PLANNING COMMISSION REPORT
Regular Agenda – Public Hearing Item

ITEM NO. 6: SPECIAL USE PERMIT; FAST ORDER FOOD WITH DRIVE-IN; 4300 W 24TH PLACE (SLD)

SUP-15-00521: Consider a Special Use Permit for approval of a neighborhood commercial shopping area that includes one building to house a Fast Order Food, Drive-in, located at 4300 W 24th Place. The plan proposes 31,625 sq. ft. of commercial development in five buildings with four drive-in uses indicated. Submitted by Paul Werner Architects, for RPI, LLC, property owner of record.

Figure 1: Pedestrian Focal Points

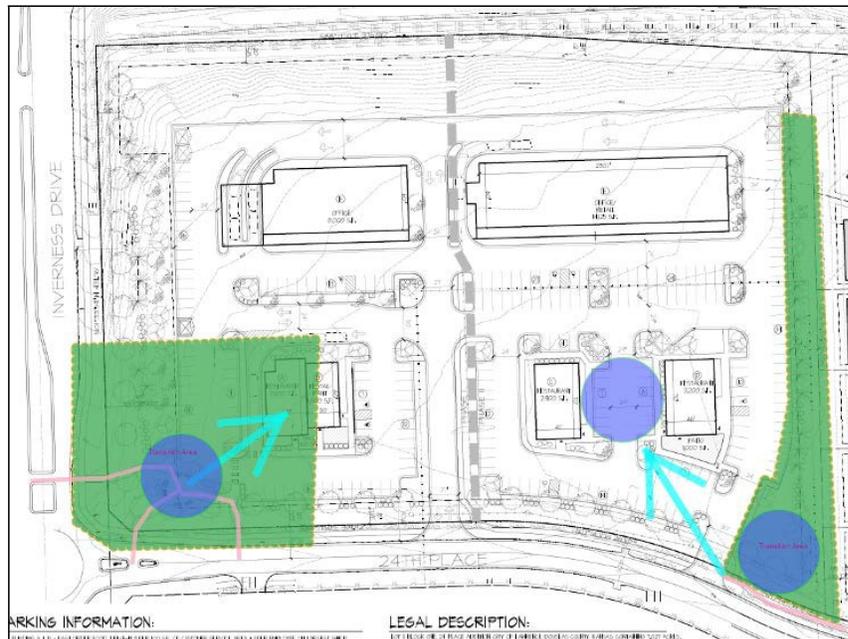
The following graphic highlights the buffer areas, initial pedestrian pathways and focal points of the development. Transition areas at the southwest and southeast corners of the site are not appropriate locations for auto oriented uses (drive-in) in this specific neighborhood context.

Pedestrian accessibility and amenities: Several pedestrian connections within the development and from the public sidewalks to the development need to be more fully developed. This plan provides a stronger pedestrian amenity at the intersection than has been seen in previous plans; however, this space immediately connects to a parking lot with crossings through a drive-in lane.

Figure 3: Commercial Design Guideline Examples

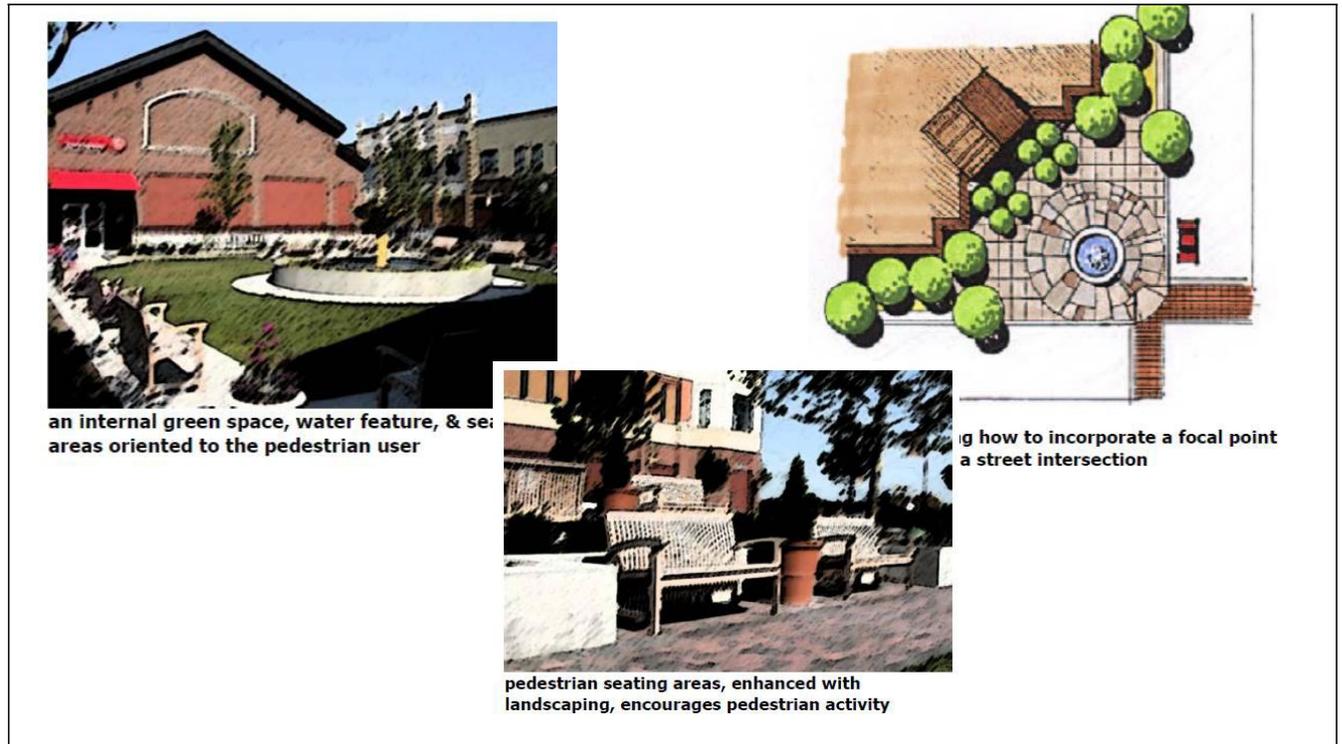
Previous development discussions of this property, and specifically the southwest corner of this property, have focused on the need for a wide buffer that provides transition between the residential uses to the west and the commercial uses to the east. These discussions have included mini-park like

areas with pedestrian amenities. The following examples of pedestrian amenities are provided for reference and can be found in the Commercial Design Guidelines (page 21).

By revising the plan and moving the Fast Order Food, Drive-in use to the north or central portion of the site, the pedestrian connections within the site can be enhanced and interior green space, open space, or patio/plaza space can be provided that allow customers or diners to overlook something other than a surface parking lot. By moving patio spaces interior to the site, between buildings, the activity is contained and sheltered from the adjacent residential uses. The residential uses on the east side include duplex lots with relatively small year yards. Dense landscaping along the perimeter provides additional buffering between the uses. An example of this shared patio space is shown below.

Table 3: Clinton Parkway Street Tree Exhibit

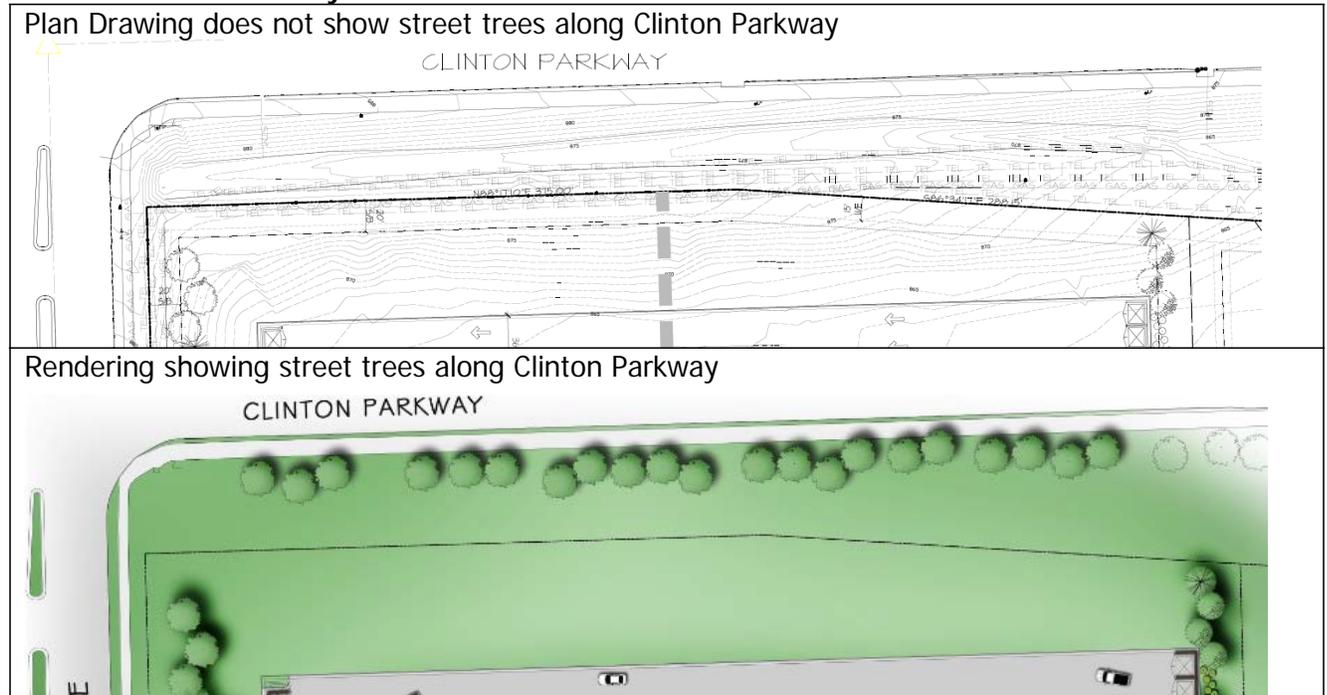
Street Trees: The proposed plan does not show the required street trees along Clinton Parkway (within the right-of-way). However, along Inverness Drive and W 24th Place, street trees are provided. W 24th Place street trees are setback north of an existing utility easement. Staff has confirmed that some utilities are using parts of the easement along the north side of W 24th Place. The proposed landscape provides trees, shrubs and berms to accommodate screening and buffering required for this development. The applicant's rendered (colored) drawing shows street trees along Clinton Parkway. The plan must be revised to include the required street trees along Clinton Parkway.

Clinton Parkway Buffer Yard. The north side of the property abuts Clinton Parkway. The existing topography includes a 10' hill with the street elevation much higher than the pad site of the buildings. The hill side creates a natural buffer between the proposed use and Clinton Parkway. The rear building facades and service areas are likely to be screened by the natural topography. It is probable that only the rooftops of the buildings will be visible from the public street.

- e. Revised the landscape notes to include street trees required along Clinton Parkway and revise drawing to graphically show the required street trees.

Figure 5: Subdivision Plat with Dedicated Buffer Yard

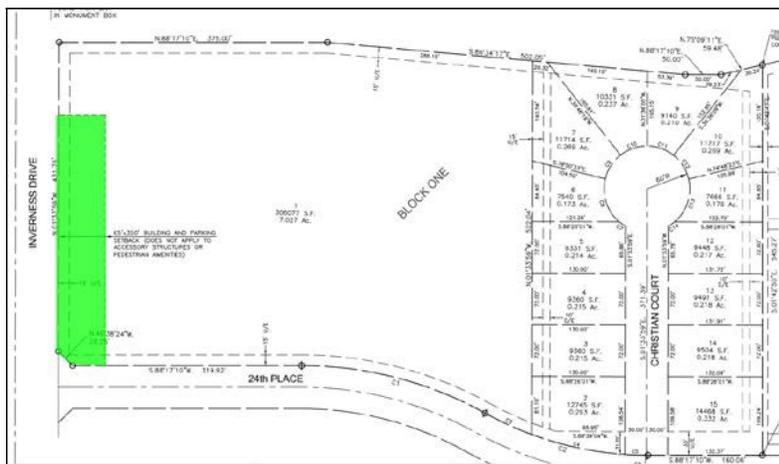
Inverness Drive Buffer Yard. Inverness Drive is the dividing line between the proposed commercial use on the east side of the street and low density residential uses on the west side of the street. The plan exceeds the required landscape planting standards for screening along Inverness Drive. This transition area is specifically shown in the Inverness Park District Plan. The plan does not prescribe a specific width of the buffer yard. It is assumed from the graphic representation and the text contained on page 19 of the plan the buffer would be more substantial than the minimum area requirements set out in the Development Code. A described buffer area along Inverness Drive was created as part of the subdivision process establishing this commercial lot. A Type 1 Buffer yard along Inverness Drive is required for this development.

Figure 6: Site Plan with Buffer Yard

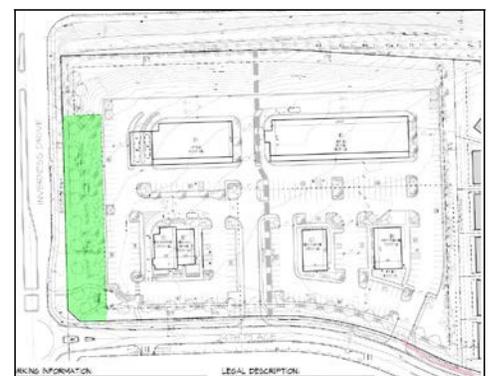
Green space extends to the north along Inverness Drive and to the east along W 24th Place. The proposed plan provides a code compliant buffer yard along Inverness Drive as shown in the following images.
